Access Compliance Report

Public Rights-of-Way

(Curb Ramps)

Intersection ID: 19937	Main Street: S_TRYON_ST	Cross Street: THORNFIELD_RD	Location: NW
ADA ID: C824D7CDB9E6	Ramp Type: Perp	Initial Pass/Fail: Fail	Overall Compliance: No
		Severity Score: 12.5

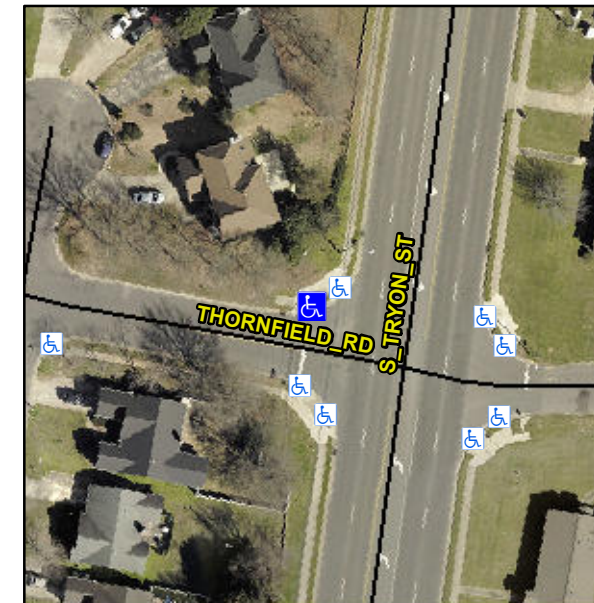
Not Found, R304.2.2

Compliance	Description	Data	Compliance	Description	Data
N/A	Ramp Length (in)	89.0	No	Ramp Slope (%)	8.4
Yes	Ramp Width (in)	48.0	Yes	Ramp XSlope (%)	2.0
N/A	Flare Type LT	N/A	N/A	Flare Type RT	N/A
N/A	Flare Slope LT (%)	N/A	N/A	Flare Slope RT (%)	N/A
N/A	Flare Traversable LT?	N/A	N/A	Flare Traversable RT?	N/A
N/A	Landing Length (in)	N/A	N/A	DWS Provided?	N/A
N/A	Landing Width (in)	N/A	N/A	DWS Contrast?	N/A
N/A	Landing Slope (%)	N/A	N/A	DWS Length (in)	N/A
N/A	Landing X Slope (%)	N/A	N/A	DWS Full Width?	N/A
N/A	Landing Curb? (Y/N)	N/A	N/A	DWS Offset (in)	N/A
N/A	Shared Landing?	N/A			
N/A	Gutter Ponding?	N/A	N/A	Gutter Slope (%)	N/A
N/A	Gutter Lip Ht (in)	N/A	N/A	Gutter X Slope (%)	N/A
N/A	Painted X Walk1?	No	N/A	Painted X Walk2?	N/A
	X Walk 1 Direction	To S		X Walk 2 Direction	N/A
N/A	X Walk 1 Width (in)	N/A	N/A	X Walk 2 Width (in)	N/A
	X Walk 1 Slope (%)	1.2		X Walk 2 Slope (%)	N/A
	X Walk 1 X Slope (%)	2.6		X Walk 2 X Slope (%)	N/A

Remove & Replace Entire Ramp.
